From: [REDACTED]
Sent: Saturday, 22 August 2026 12:02 AM
To: Enquiries; [REDACTED]
Subject: FORMAL OBJECTION TO DEVELOPMENT APPLICATION CA 2025_5732/1

Development Application CA-2025_5732/1

Combined Development — Workers' Accommodation, Tourist Park,
Caretaker's Accommodation and Advertising Device
Lot 2 Captain Cook Highway, Lot 3 AP15871, Crees Creek and Lot 168 Endeavour Street, Port Douglas
Applicant: Krystal Marie DeMenna

"Birdsong" BnB circled in red below. Much further away than the proposed development.

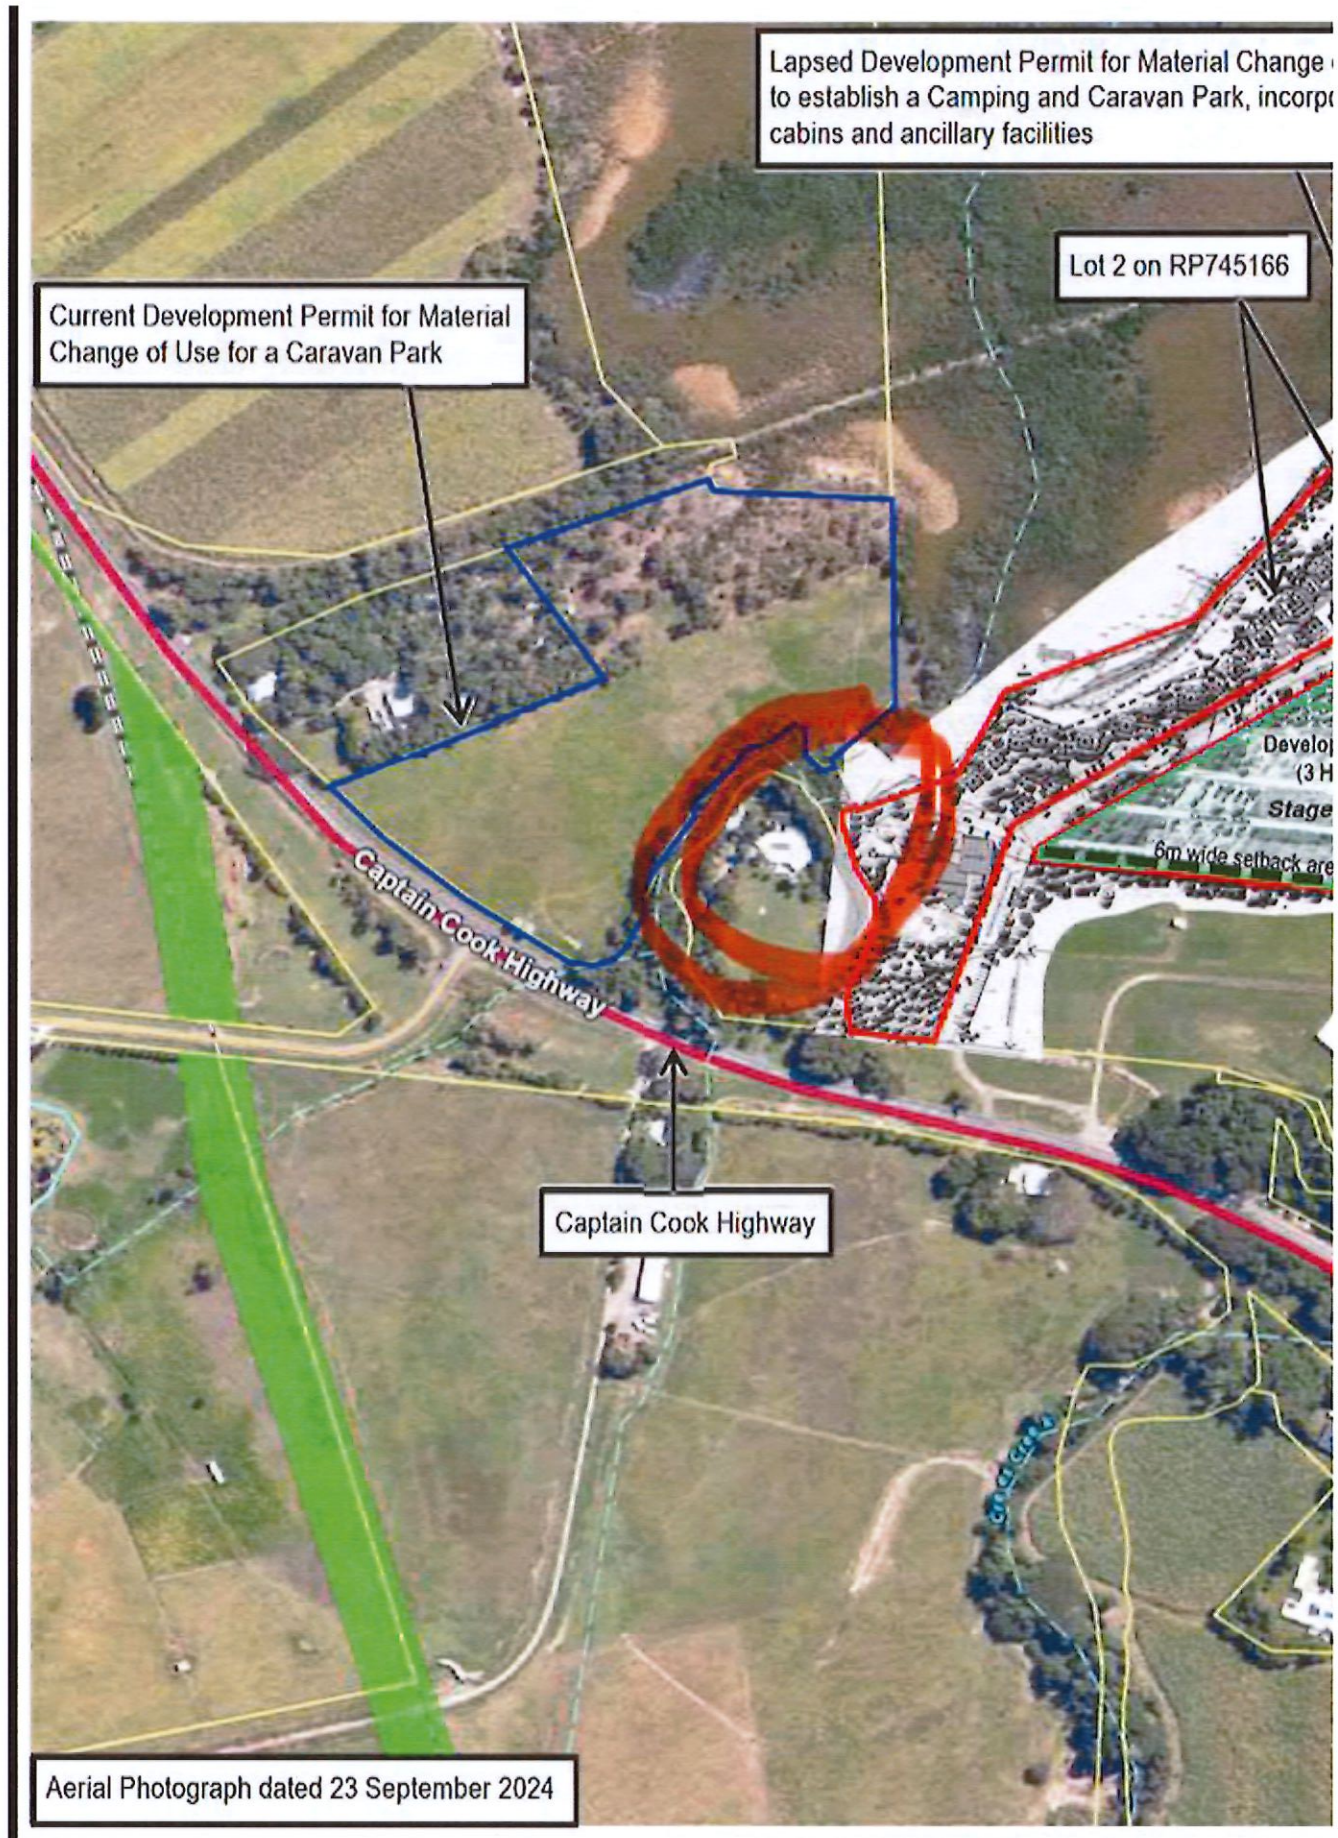
I can tell you from direct experience that sound carries from this area to Endeavour Street backyards. Music from rare, brief private events at Birdsong BnB reaches as clearly as if the event were in our backyards. But these events are rare and we know they will stop at 10pm. A permanent camp kitchen, recreation area, and 500+ transient occupants working predominantly in hospitality, operating every day and night is a different proposition. Yet it has not been modelled.

By describing the site as "discrete" from the highway, they are pushing the development toward us. No setback, no acoustic buffer, no operating hours, and no noise management plan have been specified for the Endeavour Street and Egret Close boundary.
